Groundwater Application Review Summary Form

Application # G- 18920

PUBLIC INTEREST REVIEW FOR GROUNDWATER APPLICATIONS

TO: Water Rights Section Date 3/31/2020
 FROM: Groundwater Section Jen Woody
 Reviewer's Name
 SUBJECT: Application G- 18920 Supersedes review of n/a
 Date of Review(s)

Figure 2. Well Location Map

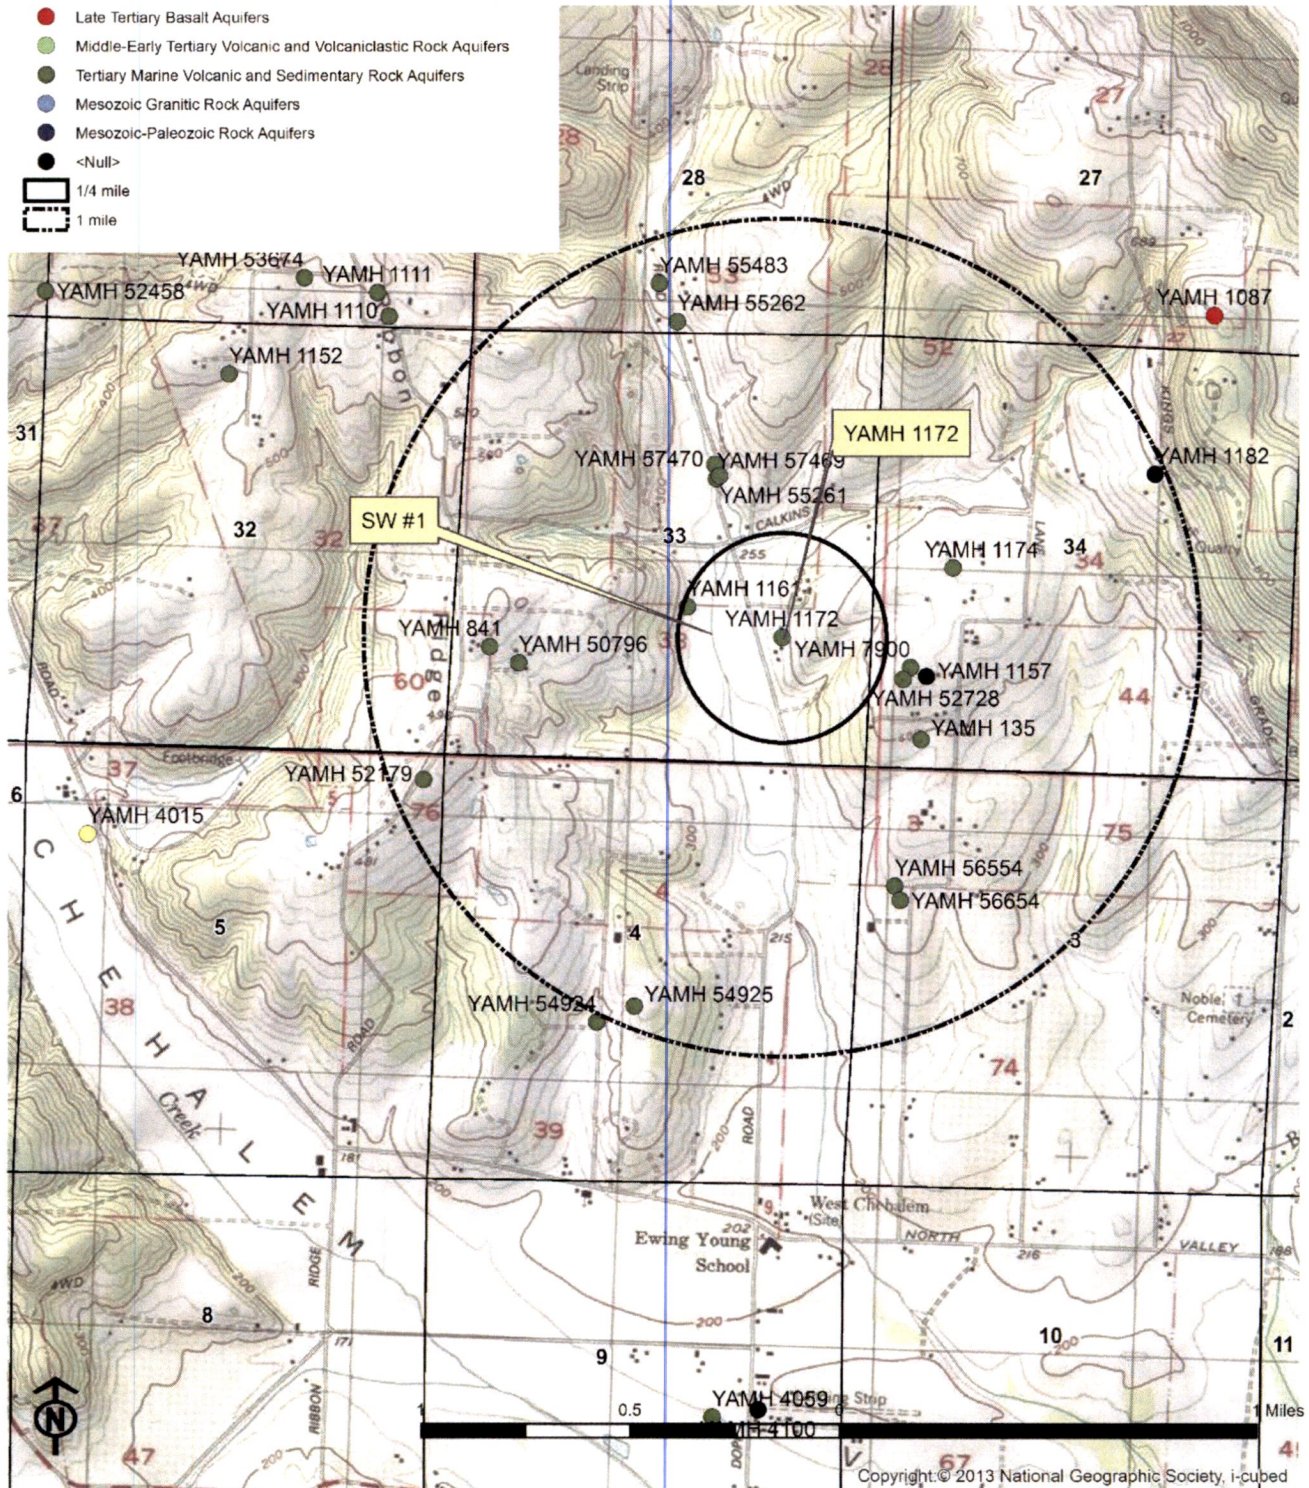
Basis for aquifer hydraulic connection evaluation: Water-table maps, where they exist, generally show flow paths that converge on local perennial streams. The open interval at the subject well is above perennial reaches of the nearby creek, and the unnamed tributary to Chehalem Creek has incised through several hundred feet of marine sediments. Groundwater from the uplands likely discharges to surface water down-gradient, providing baseflow or spring flow to sustain nearby perennial reaches of the creek.

PSI is triggered because the pumping rate is greater than 1% of 0.39 cfs (natural streamflow) and the well is less than 1/4 mile from the creek.
